EPA Evaluation of the Wickliff Polarizer Device Under
Section 511 of the Motor Vehicle Information
and Cost Savings Act

John C. Shelton

June, 1981

Test and Evaluation Branch
Emission Control Technology Division
Office of Mobile Source Air Pollution Control
U.S. Environmental Protection Agency

WICKLIFF POLARIZER
ACTUAL SIZE

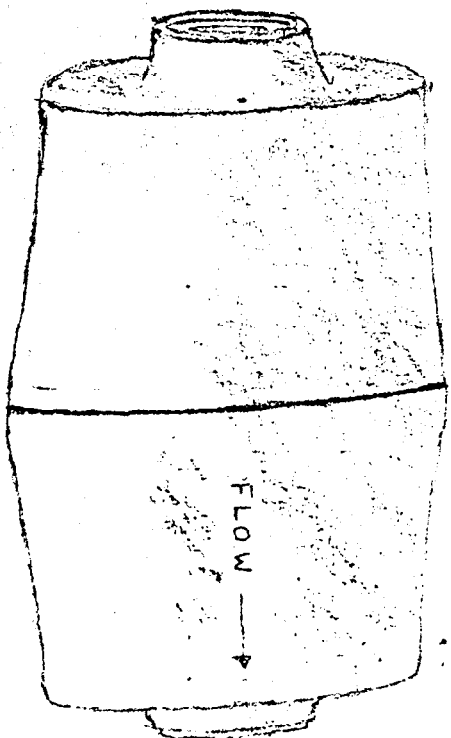
The device is judged to be inadequately described. The applicant stated "We feel that it would be detrimental to our business organization to make a disclosure as you request in your application format." A brief description is contained under Section 10 Device installation of the application. (Attachment D).

1. A copy of the patent application and information regarding the contents of the unit so that we may determine if any harmful materials are present or if any toxic compounds are likely to result from its use. We also request more information on how the fuel is polarized as it passes through the unit. You have not submitted enough background data to allow us to understand the operating principle of the device.

2. Detailed instructions on the installation of the device complete with drawings and tools required for installation.
3. Data from exhaust emission tests on a minimum of two vehicles. Duplicate tests are required both before and after the device is installed. This is a total of at least eight hot-start tests. These tests must be performed at an independent laboratory recognized by EPA. I am enclosing an updated list of these laboratories. Please refer to the information I sent you on February 2, 1981 for details on the procedure to be used in gathering data at private laboratories. I am prepared to assist you further once you have made appropriate arrangements with a laboratory. We would like to comment on your test plan before testing begins.
